# Access Compliance Report

## Public Rights-of-Way

### (Curb Ramps)

Intersection ID: 28118	Main Street: DARBY_CHASE_DR	Cross Street: KENSWORTH_CT	Location: SE
ADA ID: 62575CAF2E27	Ramp Type: Perp	Initial Pass/Fail: Fail	Overall Compliance: No
Severity Score: 8.75			
Codes/Mitigation Info/Possible Solution		Field Measurements/Component Compliance

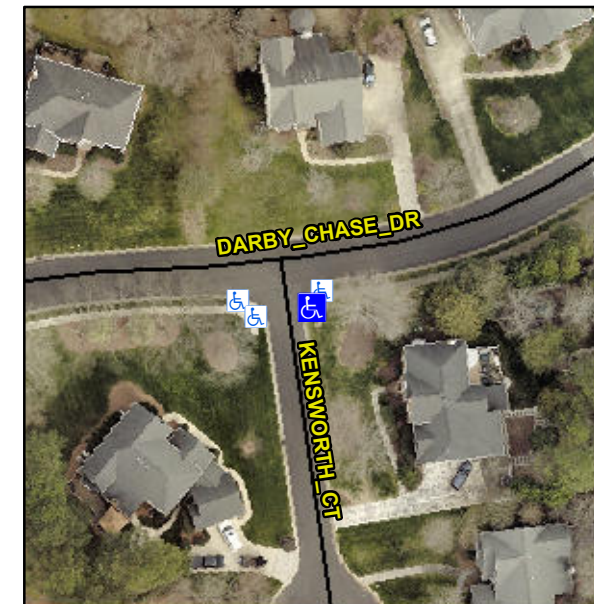
**Not Found, R304.5.1**

Compliance	Description	Data	Compliance	Description	Data
N/A	Ramp Length (in)	47.5	Yes	Ramp Slope (%)	6.2
No	Ramp Width (in)	42.0	Yes	Ramp XSlope (%)	1.8
N/A	Flare Type LT	N/A	N/A	Flare Type RT	N/A
N/A	Flare Slope LT (%)	N/A	N/A	Flare Slope RT (%)	N/A
N/A	Flare Traversable LT?	N/A	N/A	Flare Traversable RT?	N/A
N/A	Landing Length (in)	N/A	N/A	DWS Provided?	N/A
N/A	Landing Width (in)	N/A	N/A	DWS Contrast?	N/A
N/A	Landing Slope (%)	N/A	N/A	DWS Length (in)	N/A
N/A	Landing X Slope (%)	N/A	N/A	DWS Full Width?	N/A
N/A	Landing Curb? (Y/N)	N/A	N/A	DWS Offset (in)	N/A
N/A	Shared Landing?	N/A			
N/A	Gutter Ponding?	N/A	N/A	Gutter Slope (%)	N/A
N/A	Gutter Lip Ht (in)	N/A	N/A	Gutter X Slope (%)	N/A
N/A	Painted X Walk1?	No	N/A	Painted X Walk2?	N/A
	X Walk 1 Direction	To W		X Walk 2 Direction	N/A
N/A	X Walk 1 Width (in)	N/A	N/A	X Walk 2 Width (in)	N/A
	X Walk 1 Slope (%)	1.4		X Walk 2 Slope (%)	N/A
	X Walk 1 X Slope (%)	0.4		X Walk 2 X Slope (%)	N/A

**Remove & Replace Entire Ramp.**
